TITLE WOG Upper Shelf Energy CPL Reevaluation						PAGE 1 OF 1	
PROJECT WOG	AUTHOR <i>[Signature]</i>	DATE 12/14/93	CHK'D BY N/A	DATE	VERIFIED BY [Signature]	DATE 12/14/93	
S.O. MUHP-5080	CALC. NO. SMT-008/93	FILE NO. WOG-949(5080)	GROUP MEM-SMT

**CAROLINA POWER & LIGHT COMPANY
H. B. ROBINSON UNIT 2
Reactor Vessel Upper Shelf Energy Re-Evaluation**

H. B. Robinson Upper Shelf Energy Re-Evaluation

DEFINITION OF ASME AND ASTM ORIENTATIONS

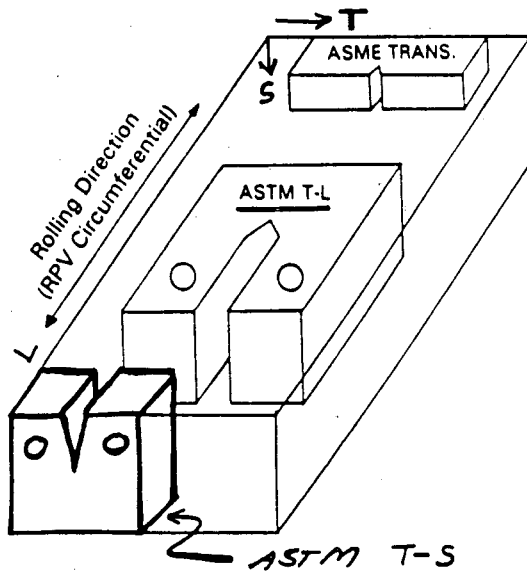
1. The initial average Charpy value assumed in Reference 1 for the material of Reference 2 was 50 ft-lbs. J_{material} is modified to reflect the actual initial value of 53.6 ft-lbs.
2. Reference 3 contains a relationship to adjust the J_{material} value of the Reference 2 ASTM A 302B plate material for different temperature values. The technique described in Reference 1 along with this temperature correction is used to calculate J_{material} for this plant.
3. Table 3-2 of Reference 1 conservatively utilizes J_{applied} for a flaw which is axially orientated with J_{material} values for the transverse direction. J_{material} is recalculated for both the transverse and longitudinal direction, and J_{applied} for circumferential and axial flaws are compared with the transverse and longitudinal values, respectively as depicted in the attached figure.

It is shown that $J_{\text{applied}} < J_{\text{material}}$ and $(dJ/da)_{\text{applied}} < (dJ/da)_{\text{material}}$ in each respective direction. Note that longitudinal/axial values are supplied for information only as irradiated Charpy Energy is predicted to remain well above 50 ft-lbs in that direction.
